On May 1, 2006 we submitted a renewal application for our SPEC Model C-1 Transport Package, certificate number USA/9036/B(U)-85. The purpose of this letter is to request the addition of two more radionuclides to the approved contents, <sup>75</sup>Selenium and <sup>169</sup>Ytterbium. These radionuclides will be contained, secured and locked within the Model C-1 in exactly the same manner as the <sup>192</sup>Iridium sealed sources.

**ADDITIONAL RENEWAL APPLICATION  
for  
NRC CERTIFICATE OF COMPLIANCE  
USA/9036/B(U)**

**June 14, 2006  
Revision (1)**

**Model SPEC C-1  
Type B(U) Radioactive Material Package**

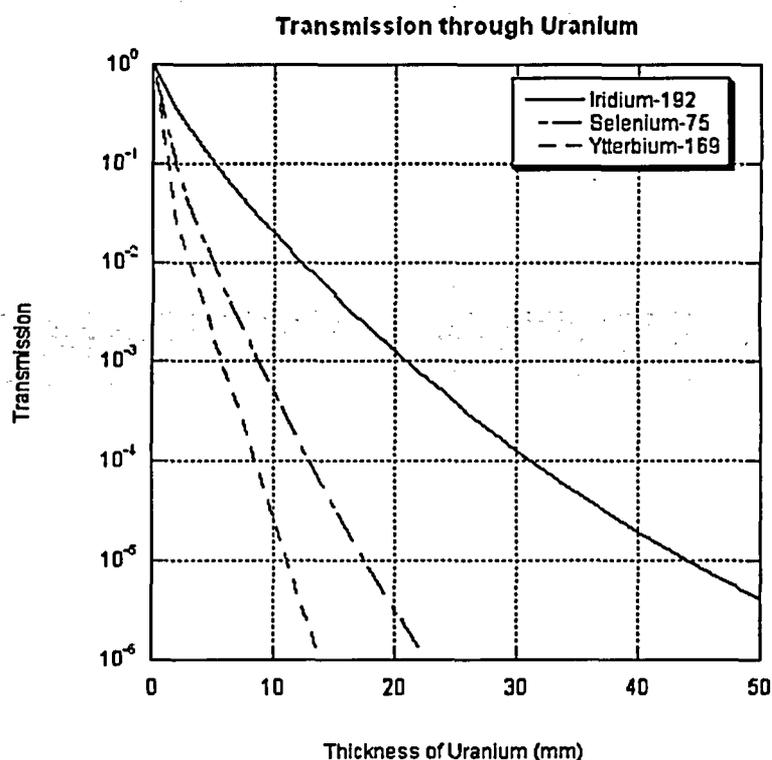
Additionally, the photon energies of <sup>75</sup>Selenium and <sup>169</sup>Ytterbium are generally lower than those of <sup>192</sup>Iridium. Therefore, the photons from <sup>75</sup>Selenium and <sup>169</sup>Ytterbium are more greatly attenuated by a given thickness of shielding than the photons of <sup>192</sup>Iridium. The attached figure shows the relative transmission of photons from each of these radionuclides through Uranium:

This demonstrates that the shielding thickness that is sufficient for <sup>192</sup>Iridium will be more efficient for the attenuation of photons from <sup>75</sup>Selenium and <sup>169</sup>Ytterbium.
